ECN/PCN No.: M1315

For Manufacturer			
<b>Product Description:</b> MOLDED INDUCTOR	<b>Abracon Part Number / Part Series:</b> AMDLA4530Q	<input type="checkbox"/> Documentation only <input checked="" type="checkbox"/> ECN <input type="checkbox"/> EOL	<input checked="" type="checkbox"/> Series <input type="checkbox"/> Part Number
<b>Affected Revision:</b> Initial Release	<b>New Revision:</b> A	<b>Application:</b>	<input type="checkbox"/> Safety <input checked="" type="checkbox"/> Non-Safety

### 3.0 Part Identification

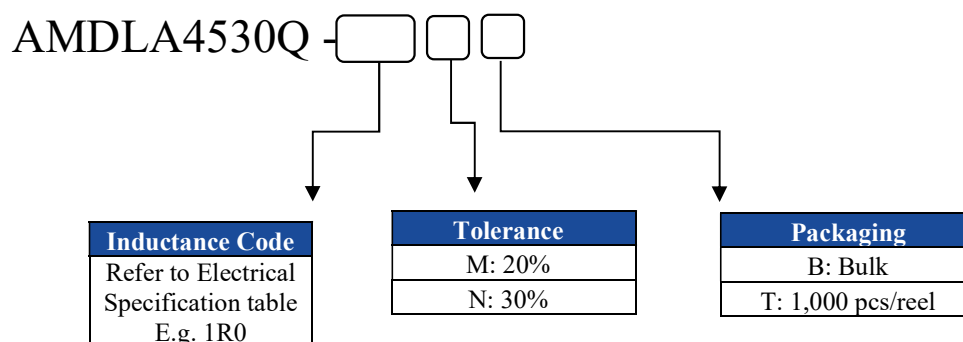
Prior to Change:

**Cause/Reason for Change:** Part Identification section was updated; part of the information in Packaging section was removed; removed R35 from the series (refer to ECN-Partial EOL M1315 AMDLA4530Q )

## 6.0 Part Identification

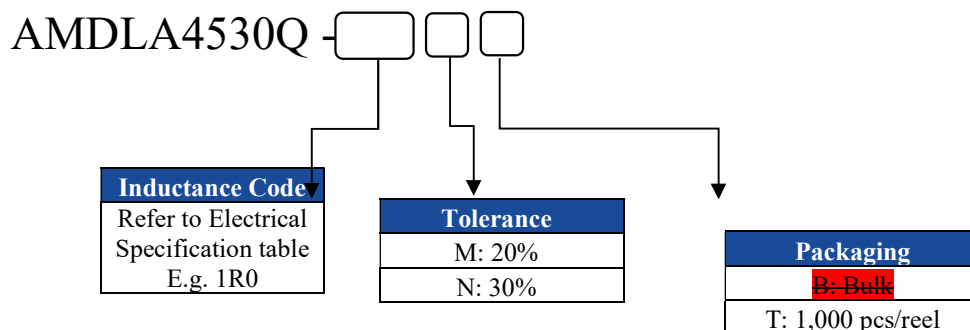
After Change:
